PARKERS RIDGE

82 SCHOOL STREET
ROLESVILLE, NC 27571

STORMWATER MANAGEMENT CALCULATIONS

G:\NCAProjects\Lemmar\8430-03 - Lemmar - School Street - Rolesville\04 - Calculations\StormCAD FILES - WORKING\Post Drainage Area Map.dwg

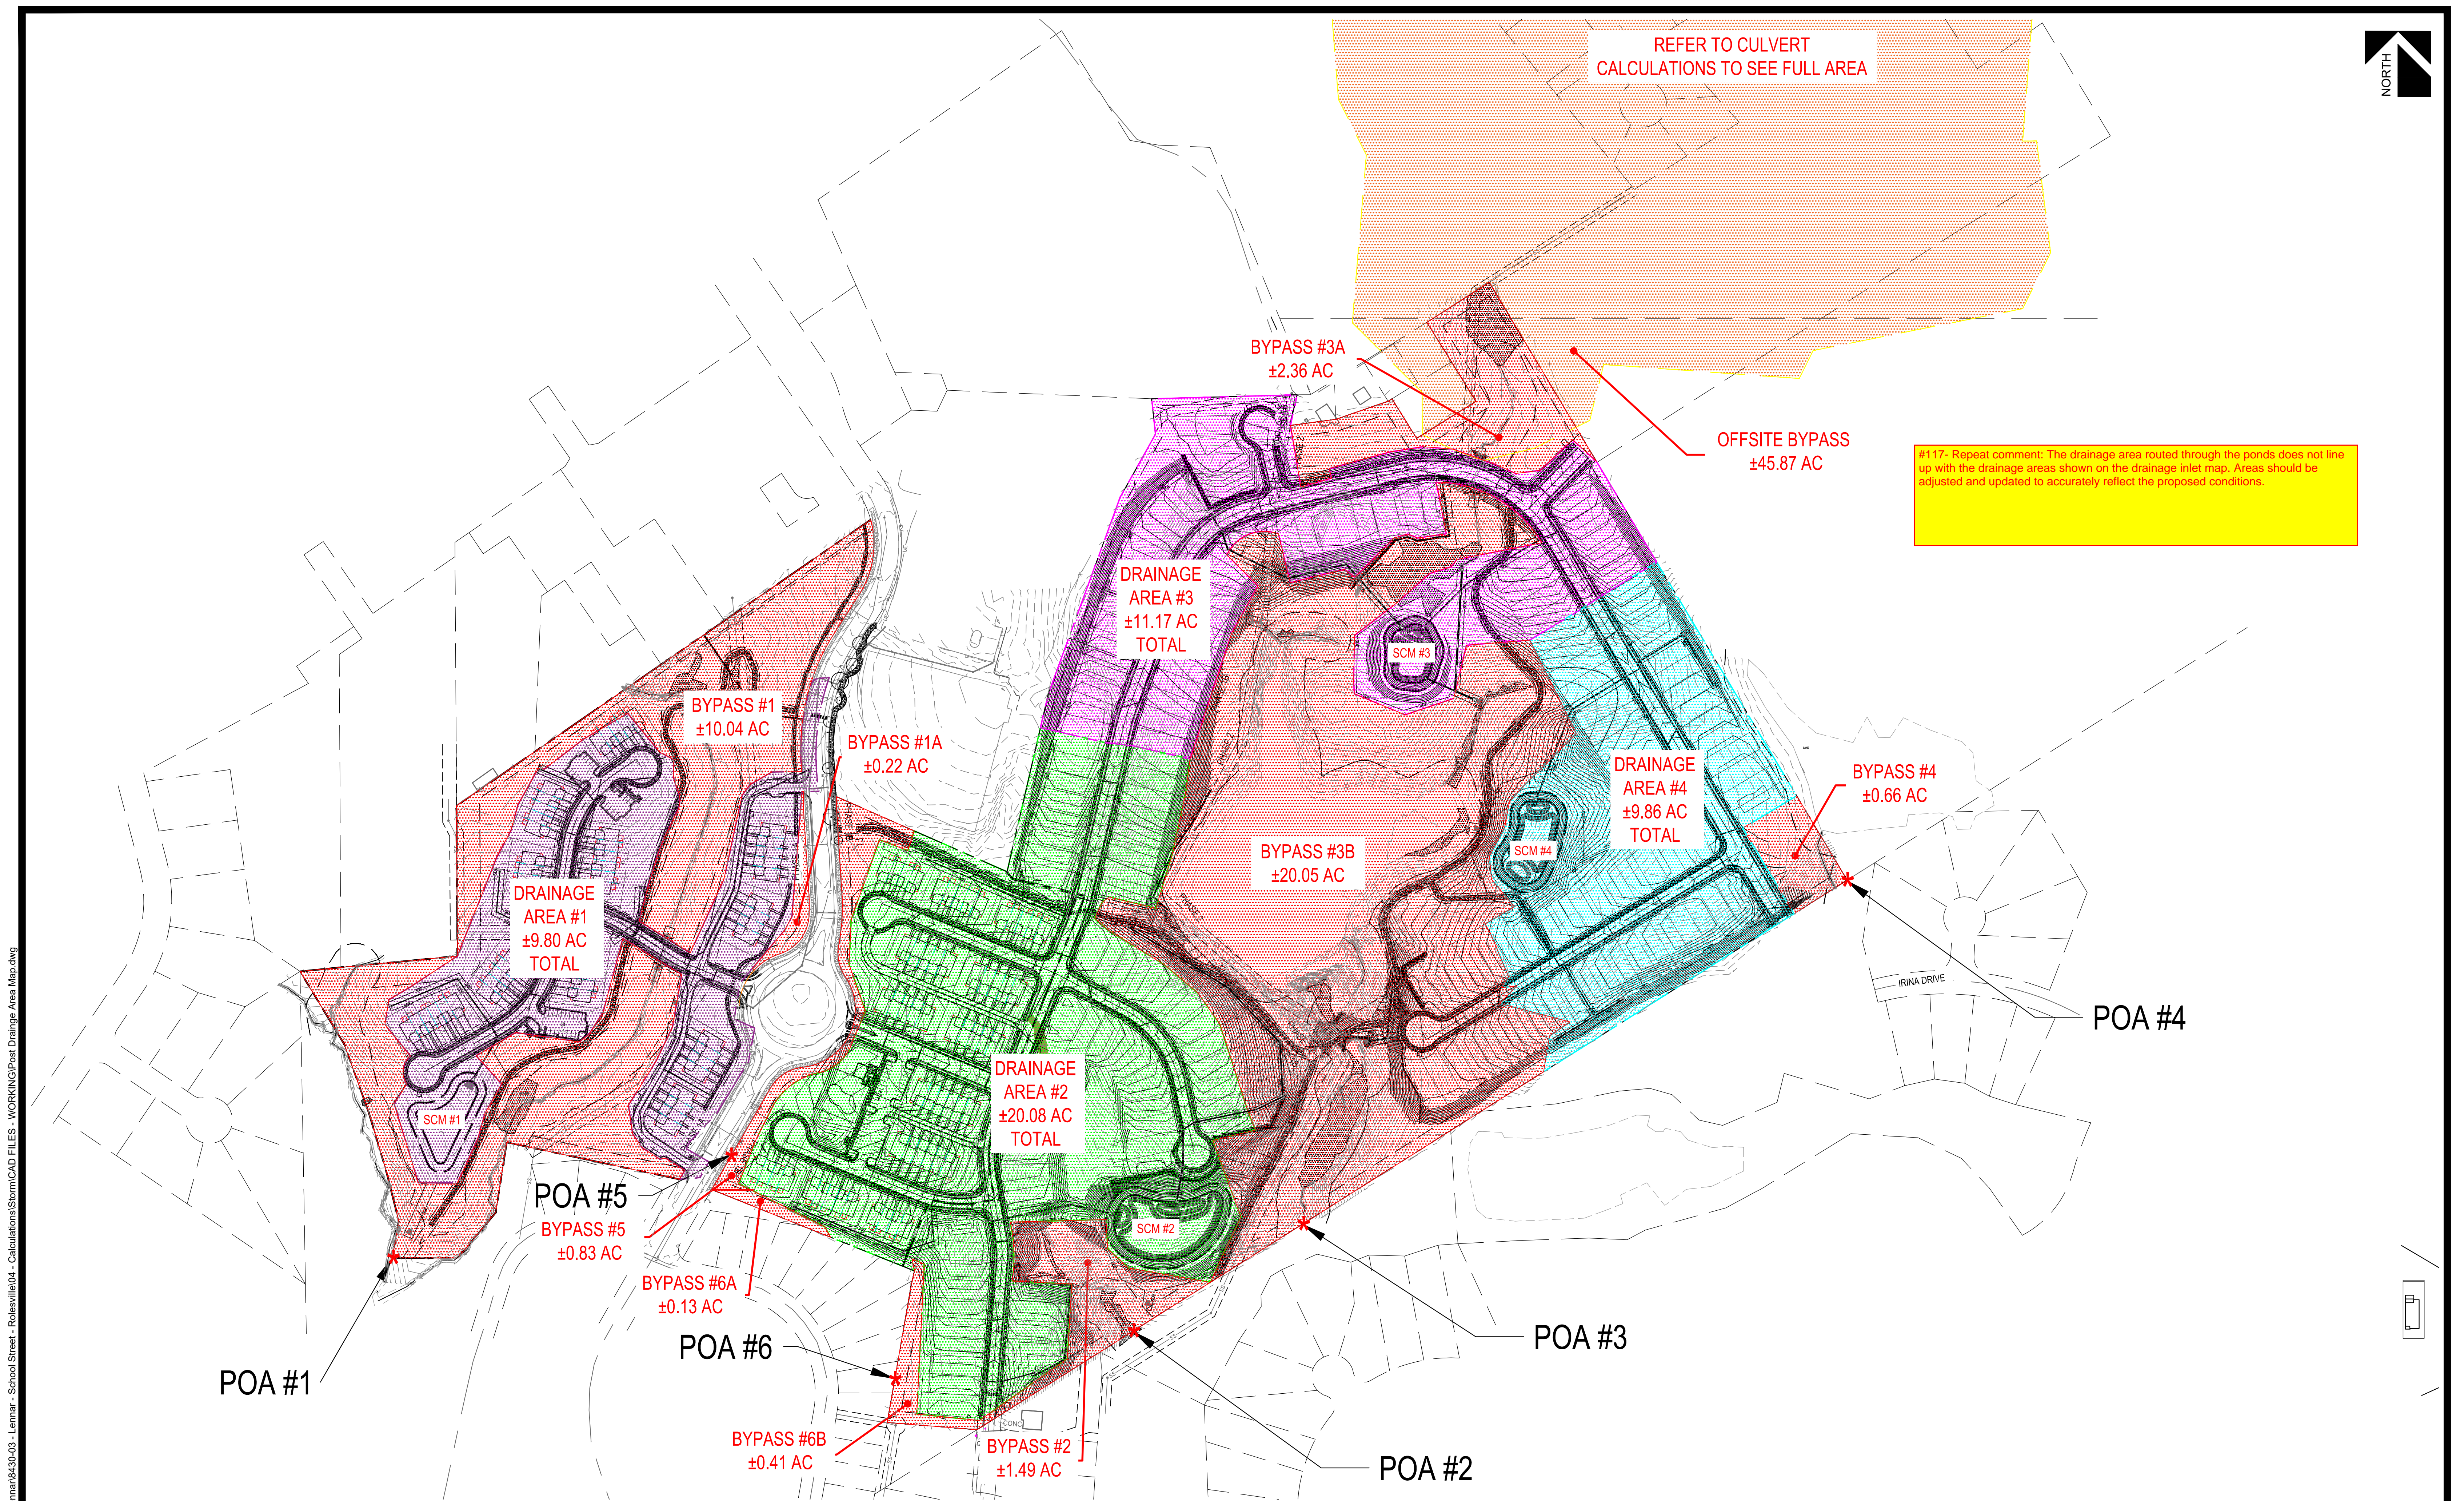
#117- Repeat comment: The drainage area routed through the ponds does not line up with the drainage areas shown on the drainage inlet map. Areas should be adjusted and updated to accurately reflect the proposed conditions.
